UNITED STATES NUCLEAR REGULATORY COMMISSION ADVISORY COMMITTEE ON REACTOR SAFEGUARDS WASHINGTON, DC 20555 - 0001

Request for Additional Information regarding Spent Fuel Transport Risk Assessment

Request for Additional Information – Spent Fuel Transport Risk Assessment

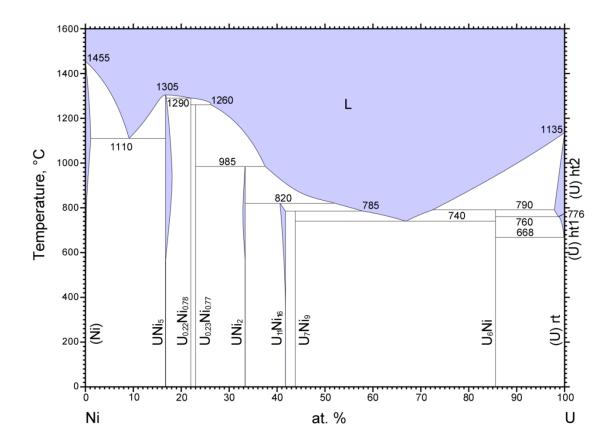
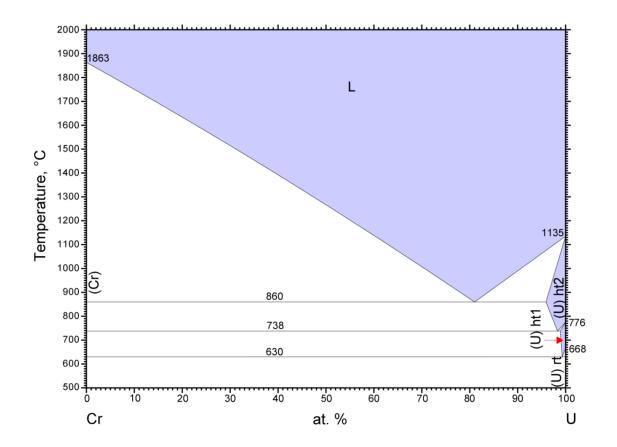
- For all cask designs in which depleted uranium shielding is used, there is a potential for rapid degradation of the cask due to interdiffusion of the cask and shielding materials at the high temperatures that may encountered in the event of a prolonged fire. During such events the uranium can expand in volume due to phase changes and potentially damage cask and seal components. Depending on time and temperature, interdiffusion of iron and uranium can lead to the formation of Laves phases and possibly liquid eutectics and lead to accelerated penetration of the canisters.

- Provide a narrative and supporting test data and analyses showing that this phenomenon has been addressed and appropriately dispositioned. Additionally, your response should address the exothermic reactions that occur when Uranium forms intermetallic compounds with iron, chromium and nickel constituents of the spent fuel transportation canisters. See phase diagrams below.
